BURLINGTON DEVELOPMENT REVIEW BOARD

Tuesday October 7, 2014

TO: Development Review Board
FROM: Scott Gustin 
DATE: October 7, 2014
RE: 15-0339VR; 31 North Avenue

Request: Variance from front yard setback on existing vacant lot.

31 North Avenue

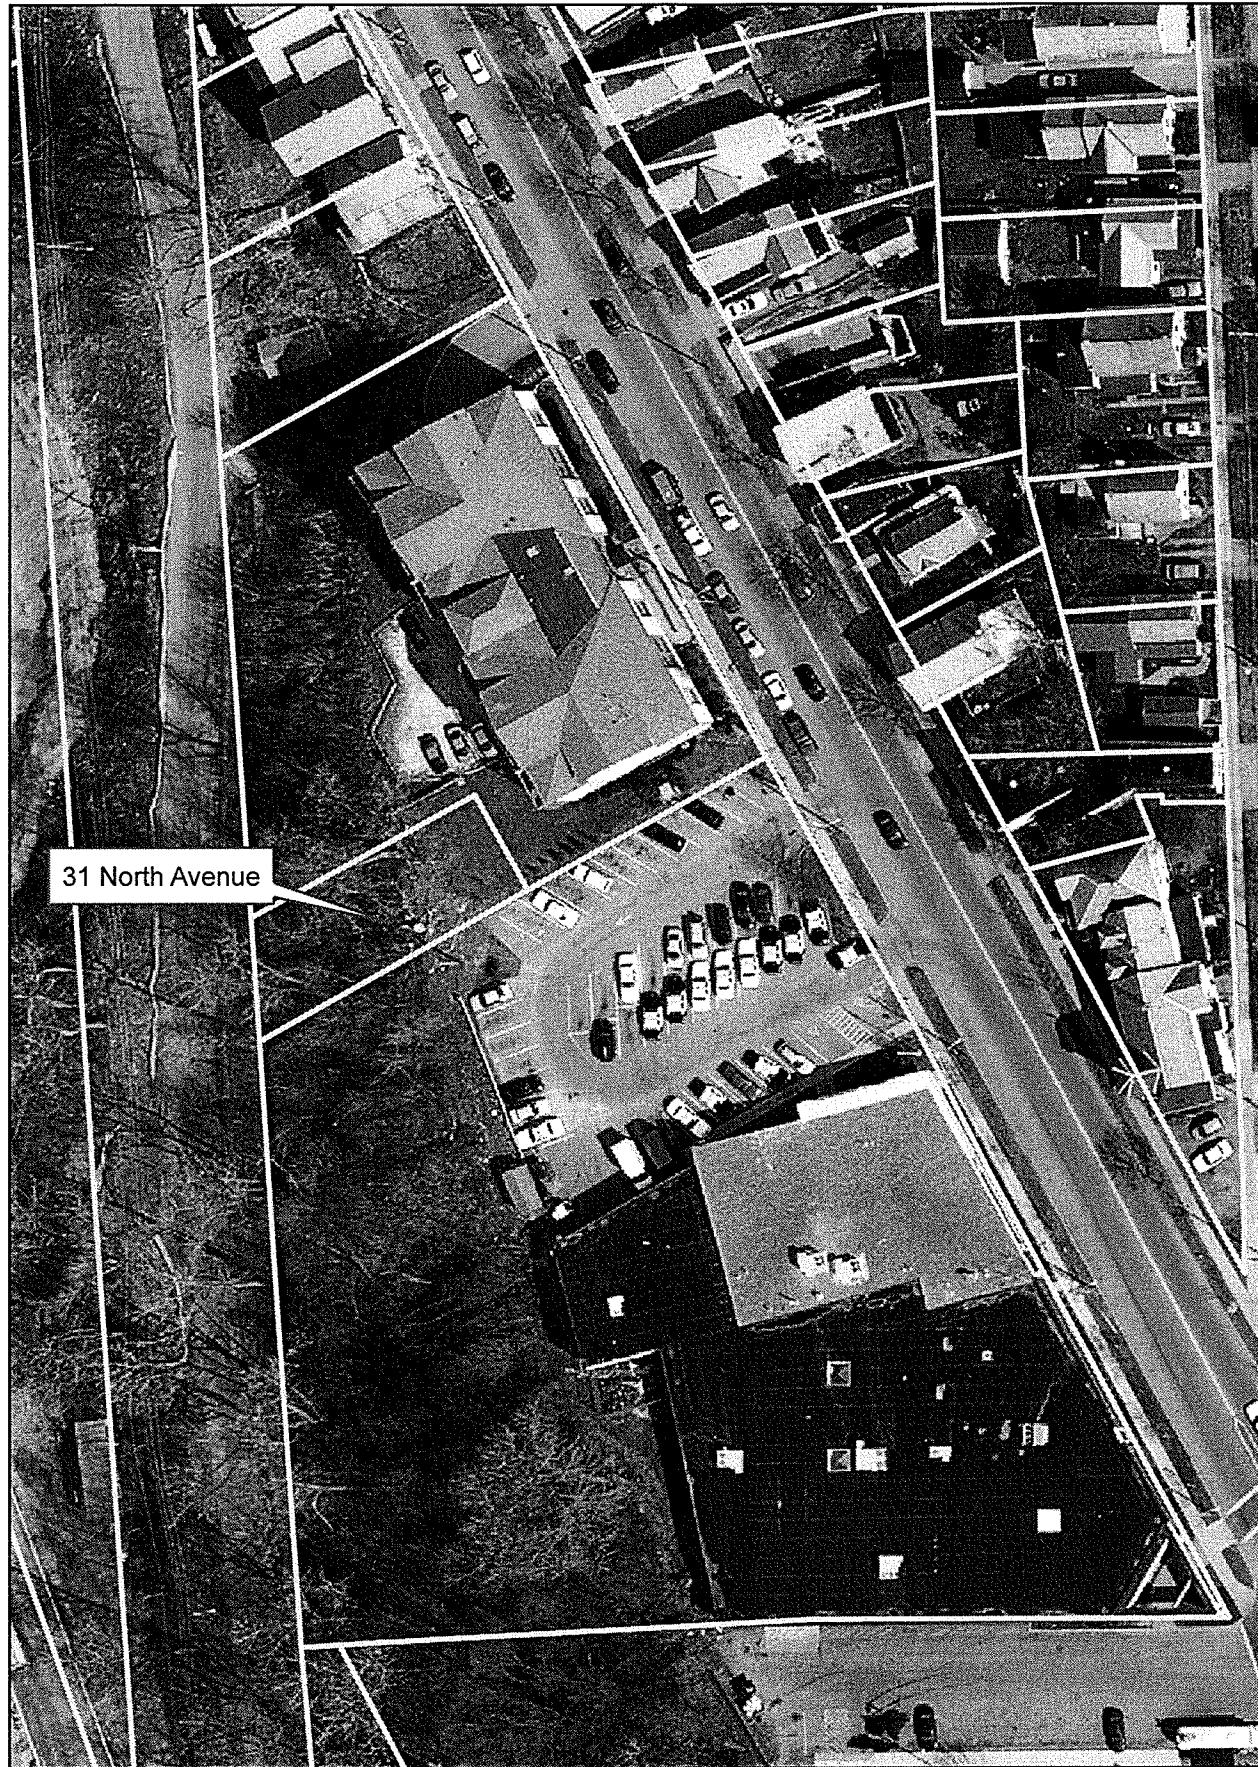
The lot is small at just 4,180 sf and 44' of road frontage. The lot is also steeply pitched except for the upper, easternmost end. The requested variance, however, does not relate to these particular characteristics. The subject property is the only one along the eastern side of Depot Street that does not also front on North Avenue. The buildings on these other properties are set close to North Avenue with relatively deep setbacks from Depot Street. The variance is requested because of the way the front yard setback is calculated per Table 4.4.5-3: *Residential District Dimensional Standards*. The front yard setback is based on the average of 2 adjacent lots on both sides of the subject lot, +/- 5'. In this case, the front yard setback is based on the average of three properties at 33, 55, and 1 North Avenue. These properties all have two front yards – on North Avenue and on Depot Street. Their front yard setbacks along Depot Street are 63', 56', and 116', respectively. The average of these setbacks is 78'. A 78' (+/- 5') on a 95' – 114' deep lot, combined with a rear yard setback of 25% results in an unbuildable lot. Compliance with the front yard setback is impossible. **(Affirmative finding)**

As noted above, a 78' (+/- 5') front yard setback combined with a 25% rear yard setback results in virtually no building envelop. Compliance with the front yard setback is impossible.
(Affirmative finding)

The requested 10' front yard setback allows for a reasonable building envelope and minimizes encroachment into the steep slope on the property. **(Affirmative finding)**

1. This variance approval is for relief from the front yard setback requirement of Table 4.4.5-3, *Residential District Dimensional Standards*.
2. No development is included in this approval. All development is subject to a separate zoning permit and must meet all other dimensional requirements.
3. Per Sec. 12.1.3, *Filing a Request, Public Hearing, and DRB Decision*, this variance approval shall be valid for a period of 2 years.

RECORD OWNER: DAVID MAYNARD, et al.
EXISTING HEIGHT: 14' +/-
PROPOSED HEIGHT: 27' +/-

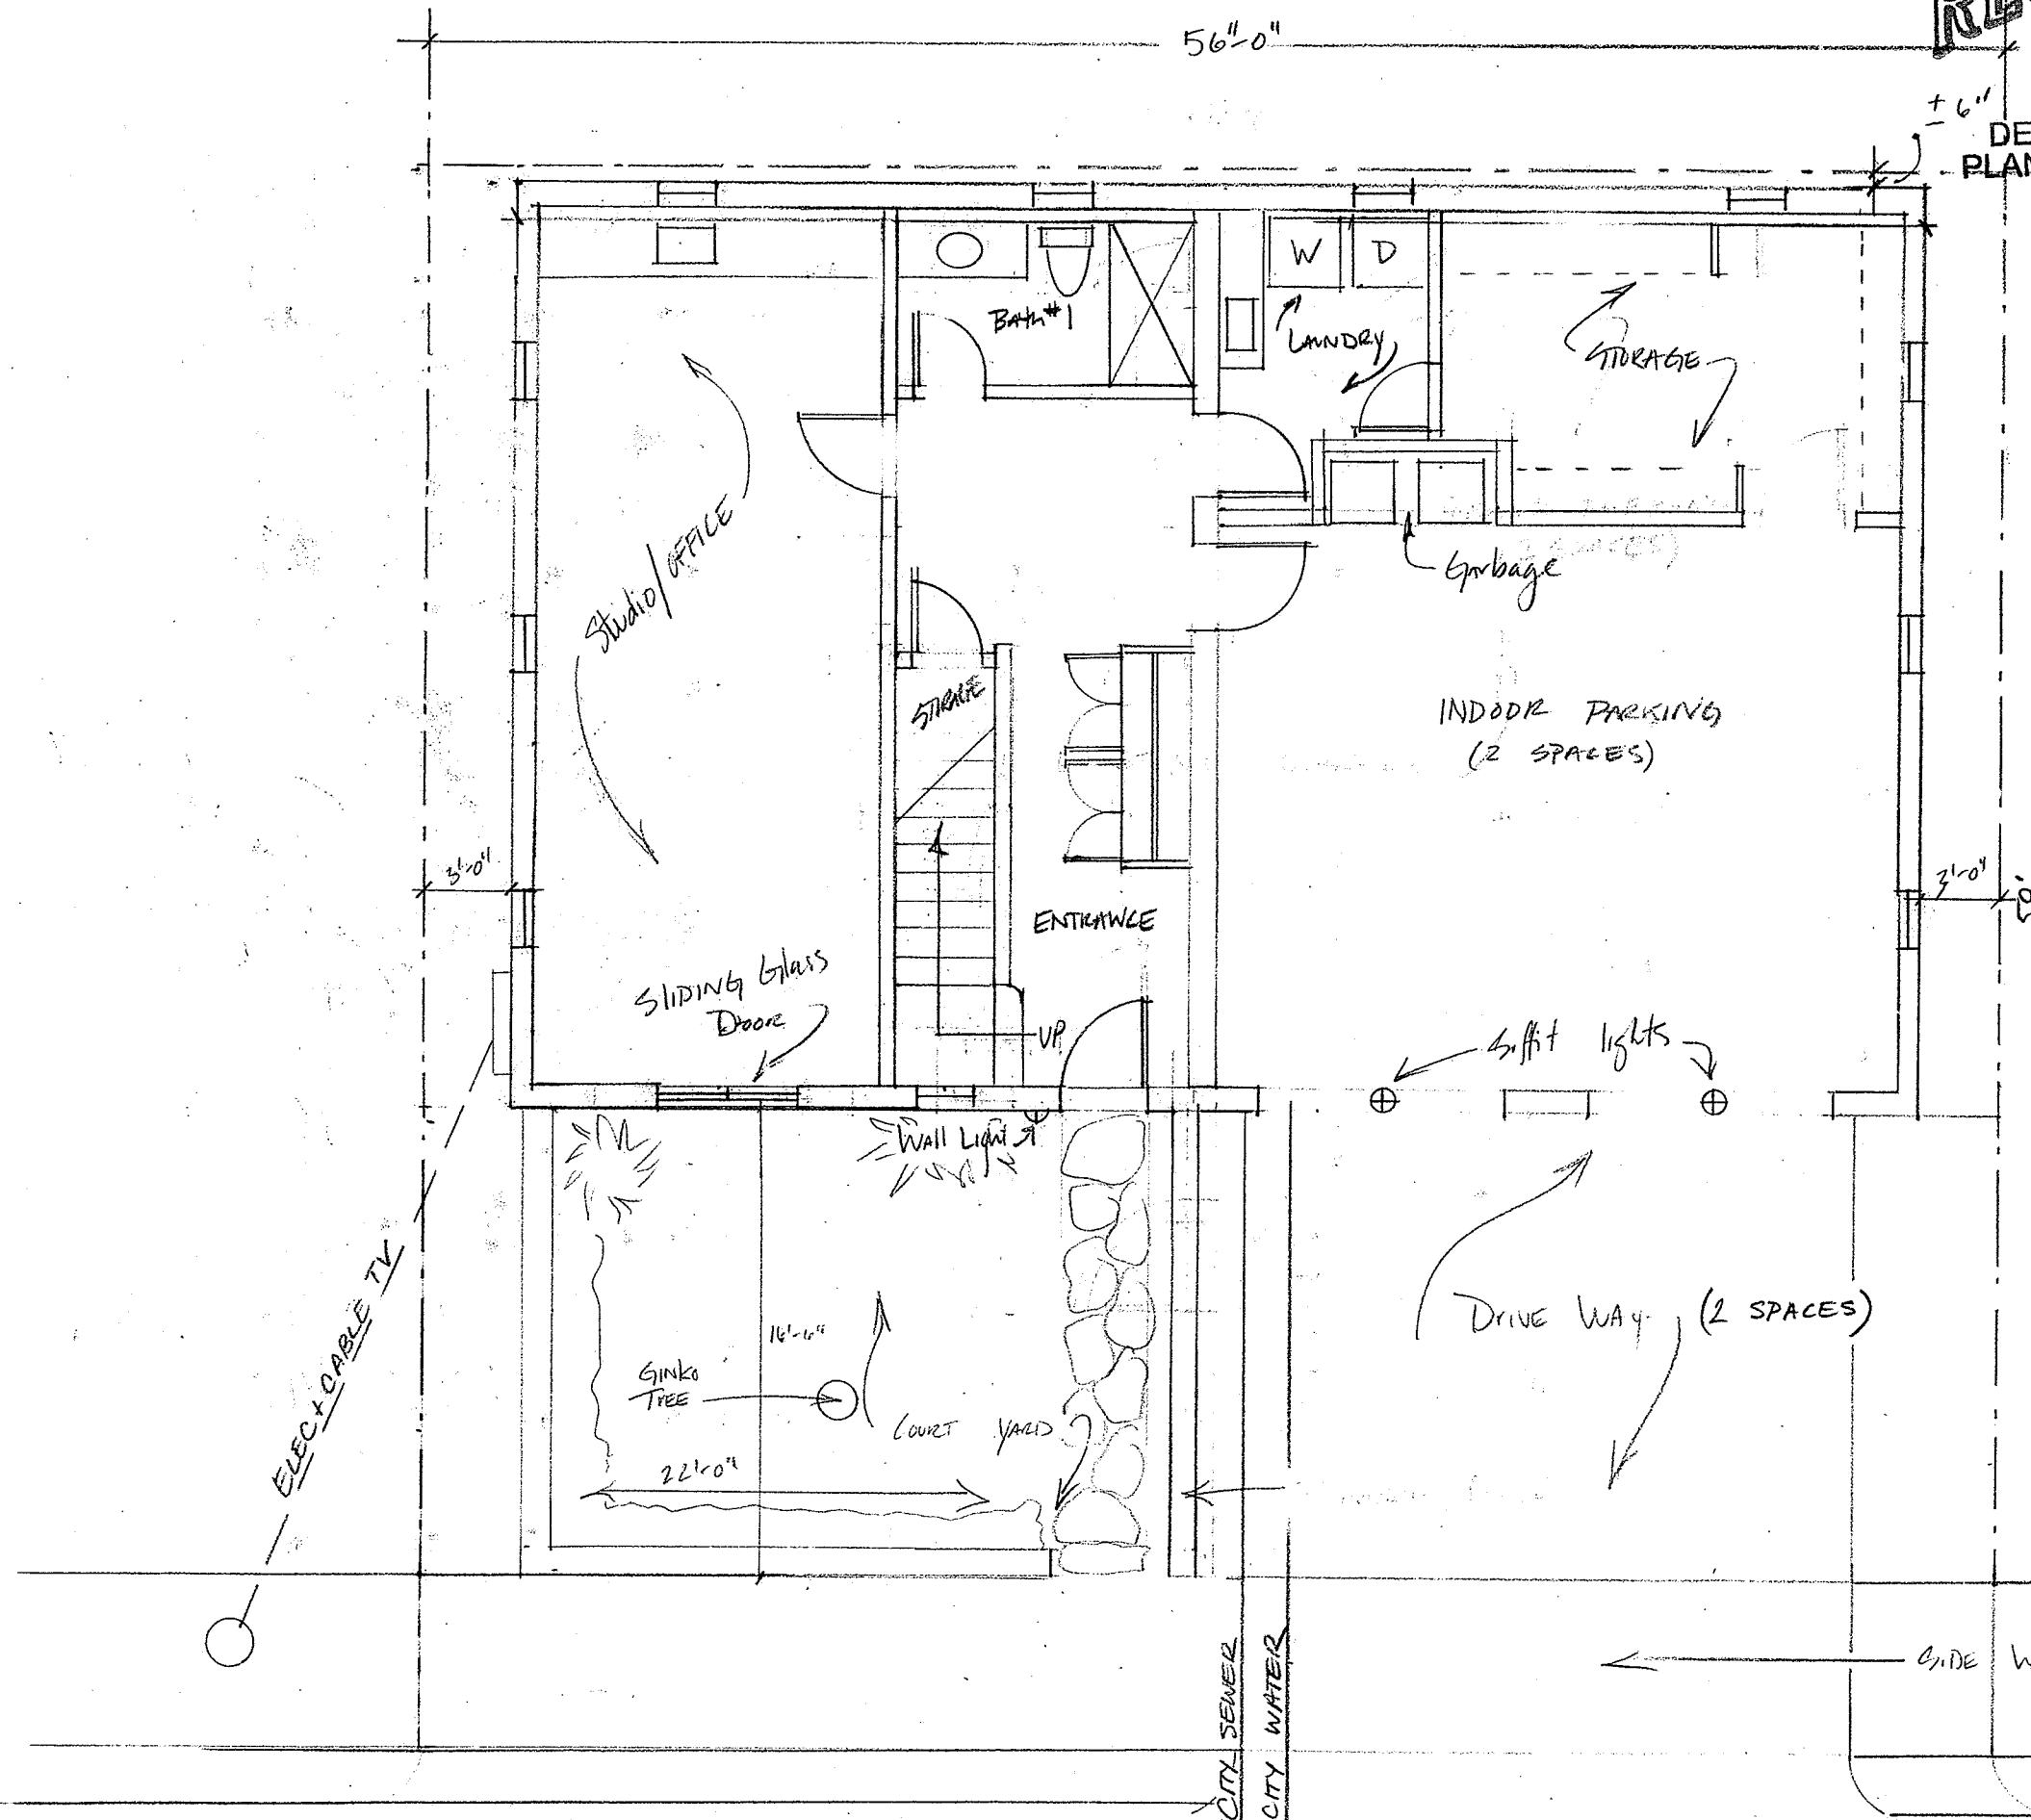
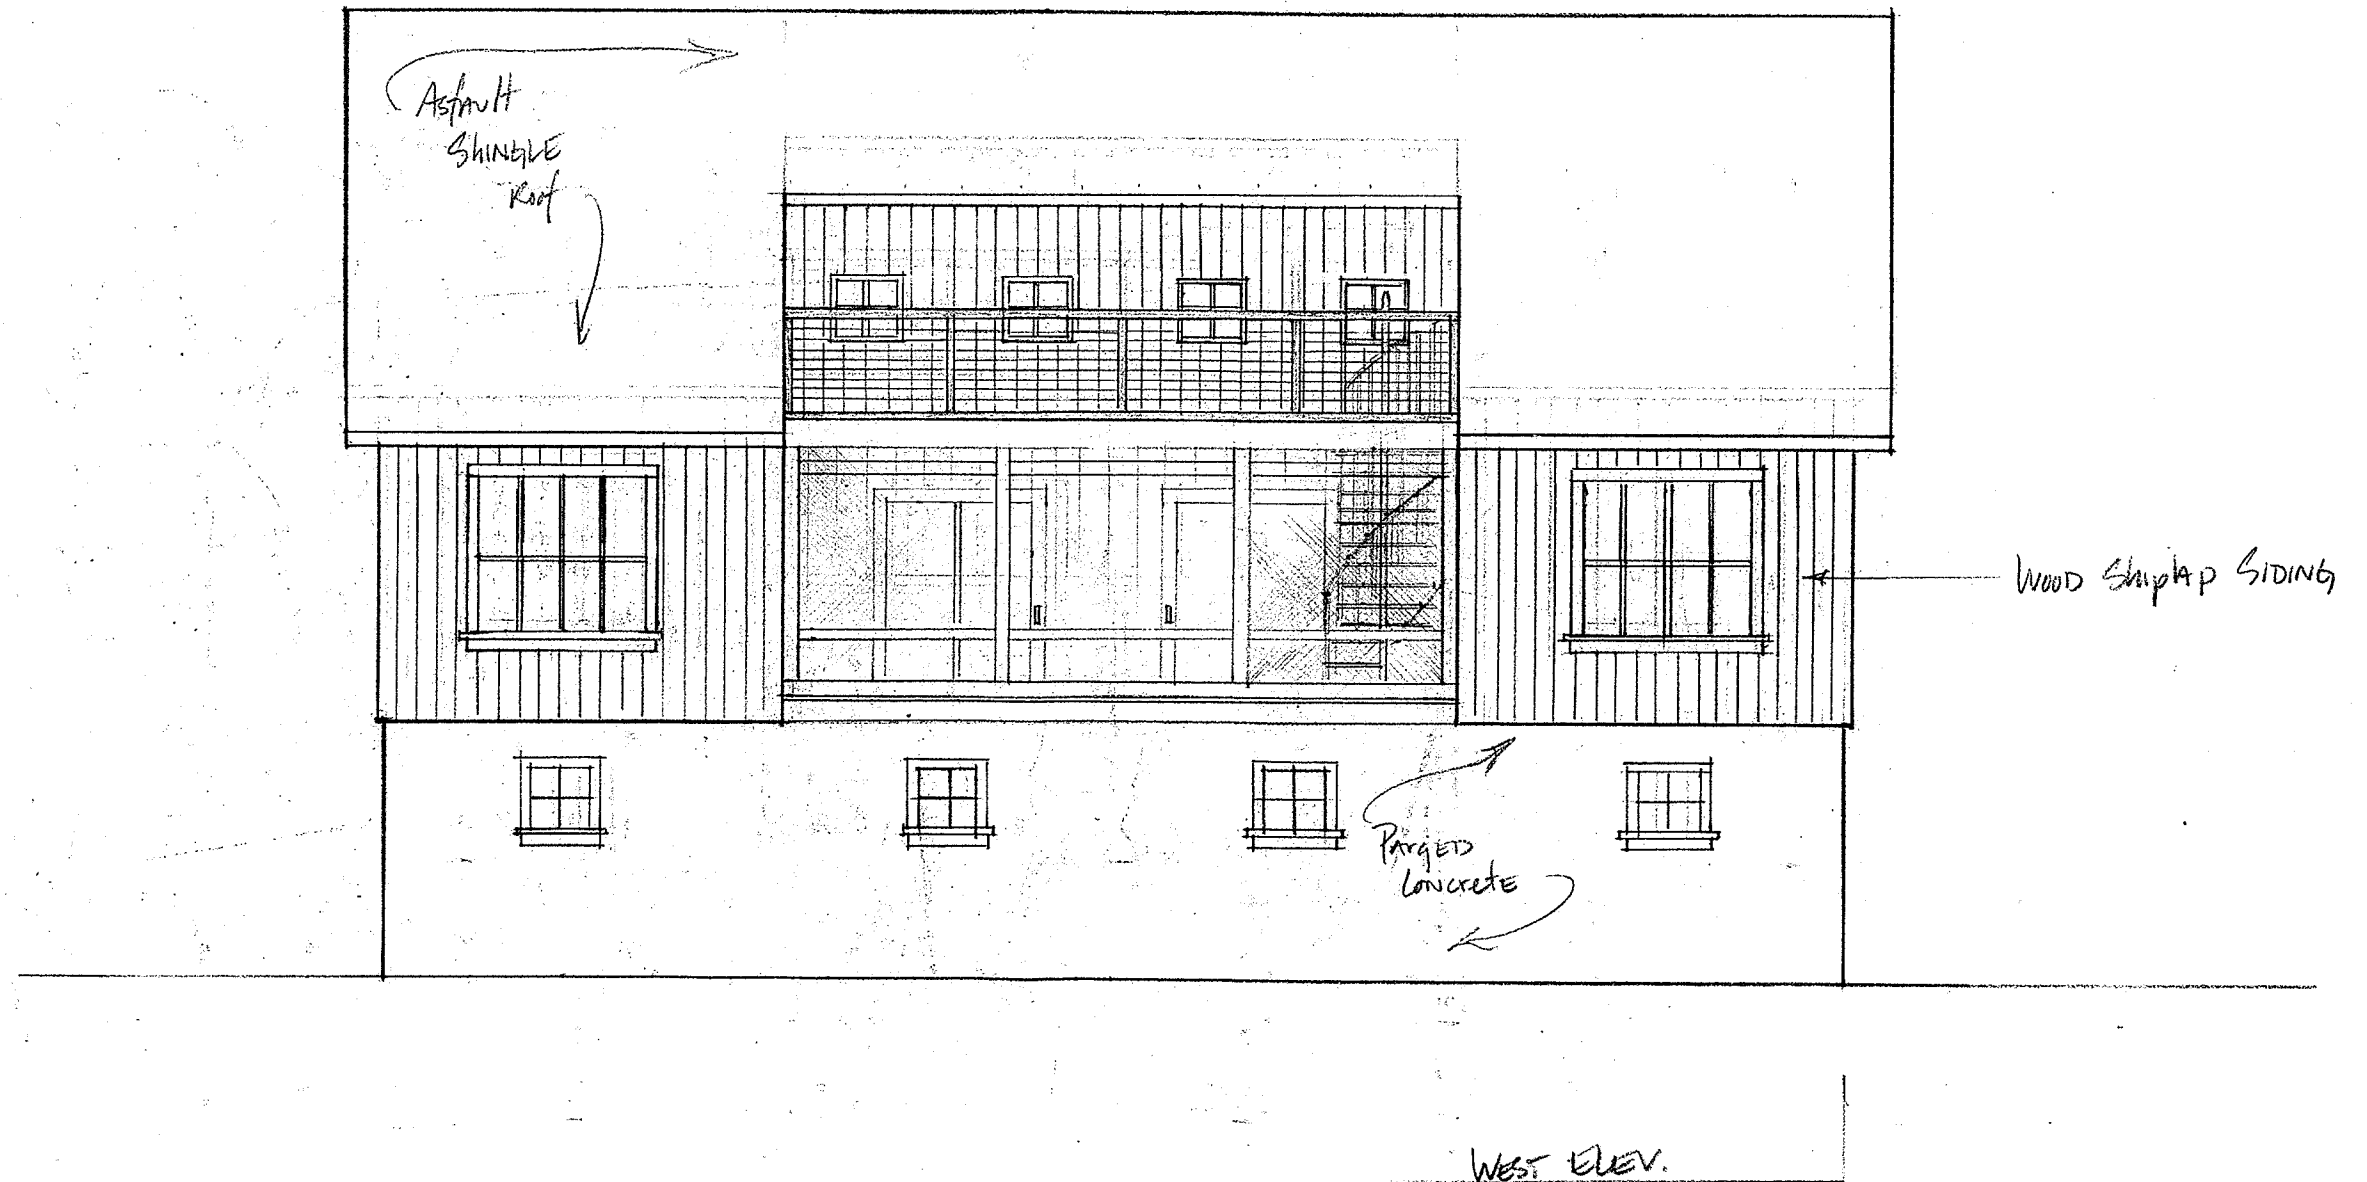
Any new utility lines must be buried. The site plan depicts a utility meter on the south side of the building. The south building elevation does not depict the utility meter. As recommended by the DAB, the utility meter must be depicted and screened. See also Sec. 6.3.2 (h) below. **(Affirmative finding if conditioned)**

As noted above, utility meters will be located on the side of the building. They must be noted on the building elevation drawing and screened per the DAB recommendation. No exterior mechanical equipment is included in the project plans. If any is proposed, it must be depicted and screened. Trash should be stored inside the garage until curb side pick-up days. **(Affirmative finding if conditioned)**

1. Revise the driveway to no more than 18' wide.
2. Note the proposed fence as wooden.
3. Screen the utility meters.

1 NEW OVERALL SITE PLAN
1/16" = 1'-0"

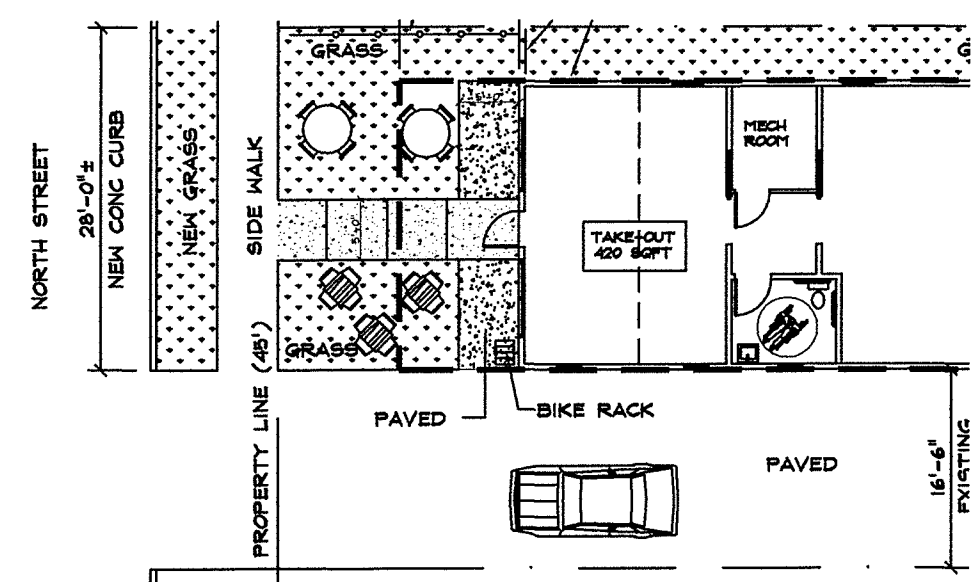
Landscaping also is necessary to be added to the parking area between the parking spaces and the north property line to prevent headlights from disturbing the adjacent residential property.

(m) Landscaping and Fences The site plan submitted shows no new landscaping except for some grass in the front of the building on which is a seating area. A concern is the ability of the grass to withstand the use by customers using this seating area. Thus, it would make sense to have an attractive hard surface such as pavers for this area and to include some plantings although additional lot coverage resulting from the pavers must remain below 60% lot coverage as required to make the neighborhood commercial use conforming.

In front of the store there is encroachment into the public ROW that has become a de facto parking area. It is accessed by a curb cut that runs the full width of the property that is not city installed or approved. This is unsightly and an unsafe situation as vehicles cross and park over the sidewalk. The plan submitted attempts to rectify this encroachment. This work within the public ROW must obtain approval from the Department of Public Works and/or Parks and Recreation as required.

2. **Prior to release of the zoning permit**, A new site/landscaping plan shall be provided that does not exceed 60% lot coverage to staff for their review and acceptance. This plan shall address the following:

- b. Landscaping shall be added to the parking area between the parking spaces and the north property line to prevent headlights from disturbing the adjacent residential property.

customers using this seating area. The revised plan is to have an attractive hard surface such as pavers for this area and to include planting islands or boxes.
